TRIP REPORT VILLAGE SAFE WATER

REPORT DATE: June 21, 2005 **REPORTER:** Greg Magee, P.E., VSW
TRIP DATE: March 25, 2005
LOCATION: Emmonak, Alaska **PROJECT NO:** N/A
PURPOSE: Mechanical and Electrical Inspections and Follow-up Evaluation of the Foundation of the New Washeteria
Accompanied by: Cindy Roberts, Denali Commission
John Faschan, P.E., EDC (Electrical Engineer)
Kevin Hanson, P.E., EDC (Mechanical Engineer)
Brian Shumaker, P.E., Duane Miller & Associates

Subject: Additional Post-Construction Geotechnical Consultation
New Washeteria Building
Emmonak, Alaska
DM&A Job No. 4135.006

Subject: Emmonak Washeteria – Site Inspection Trip Report

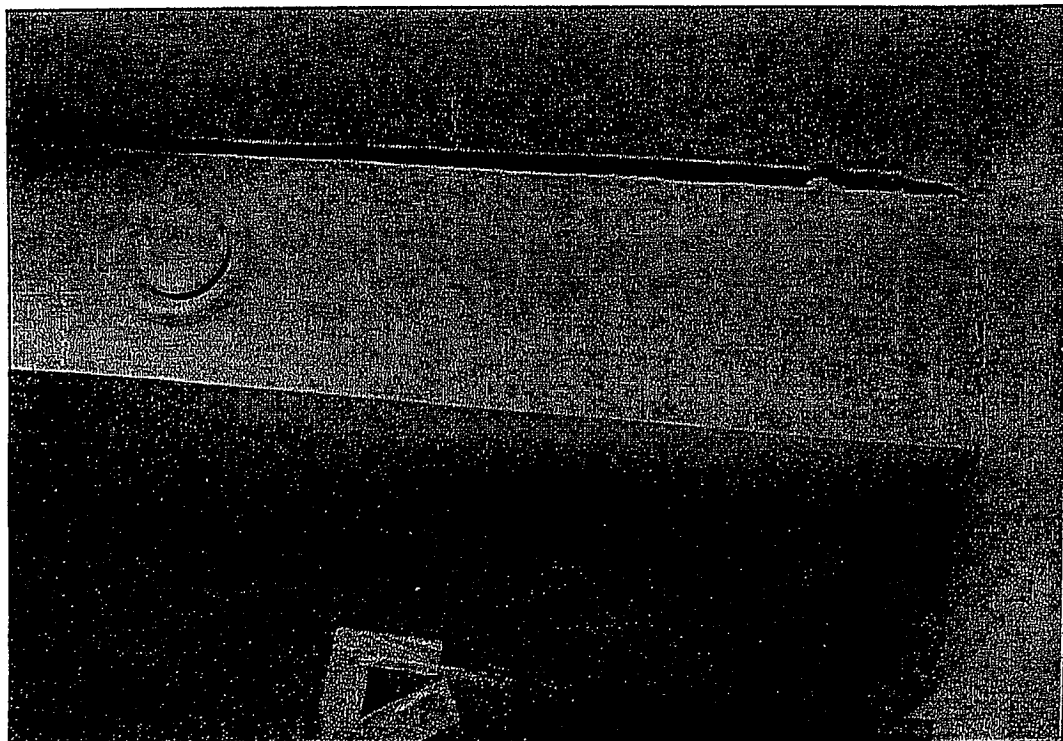
PHOTO 1. October 14, 2004: View of drywall damage at interior utility chase.

PHOTO 2. March 25, 2005: View of drywall damage at interior utility chase.

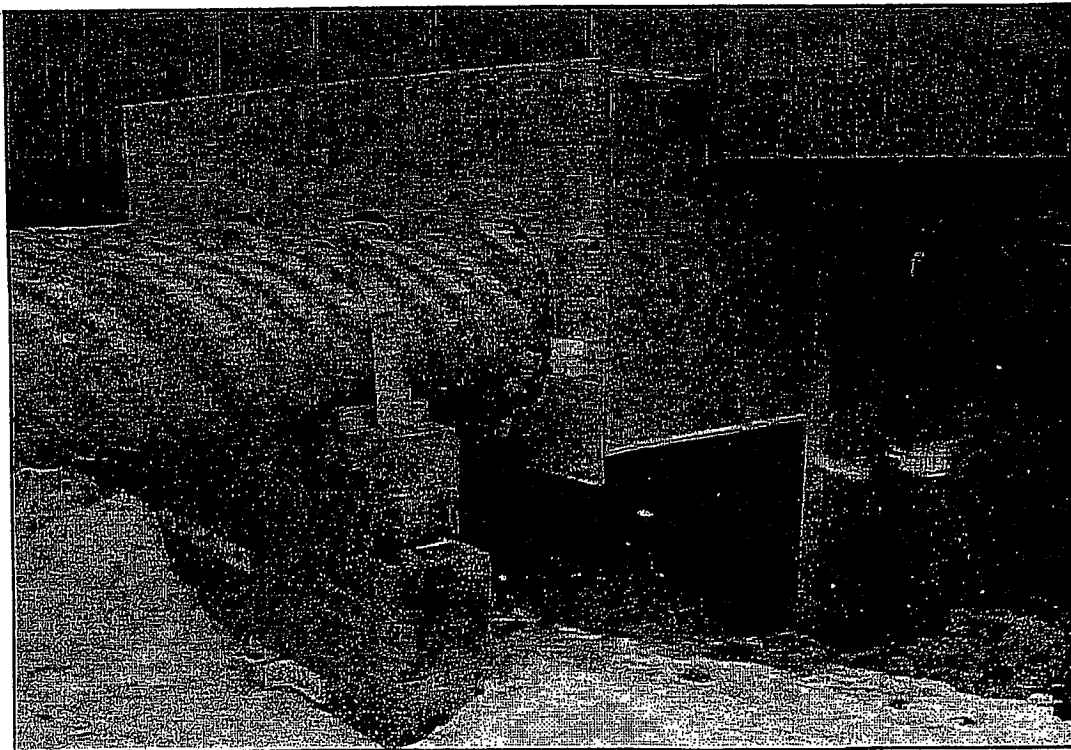
PHOTO 3. October 14, 2004: Arctic pipe enclosure damage (note large gap above top of pipes).

PHOTO 4. March 25, 2005: Arctic pipe enclosure damage (note large gap below bottom of pipes).
